Oil Leakage on Cylinder Head Cover: Insert Micro-Self-Locking Screw (166/21)

Revision: This bulletin replaces bulletin Group 1 166/21, dated December 10, 2021.

Model Lines: **Cayenne (9YA / 9YB)**

Equipment: **8-cylinder Otto engine (engine type: CVD)**

Example of an oil leakage

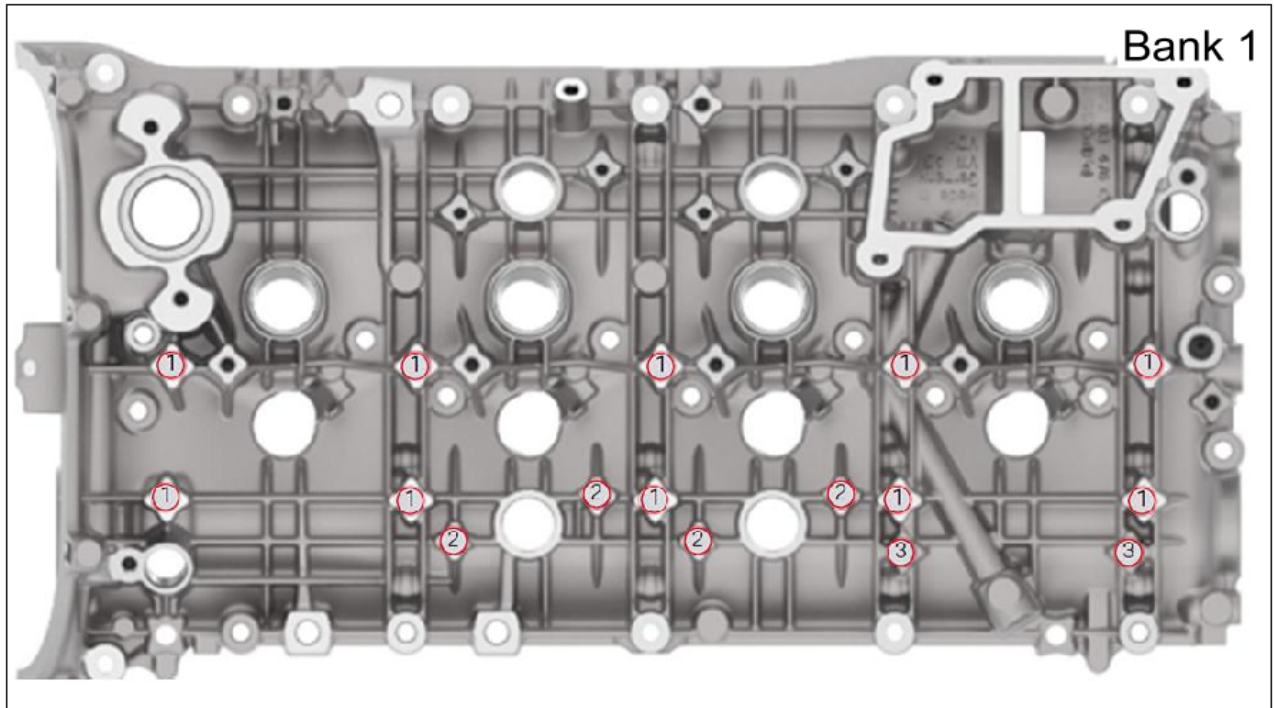
Cause: The customer complains about an oil leakage in the engine compartment. "Oil sweating" or drops of oil forming in the cylinder head cover area is detected in the workshop.

The measure described here relates to a potential oil leakage at the screws shown on the cylinder head cover. If the oil leak occurs at another location, the oil leakage must be found and remedied. This Technical Information (TI) does not apply in this case.

Action required: Clean the affected area thoroughly and replace the affected screws and adjacent screws with micro-self-locking screws.
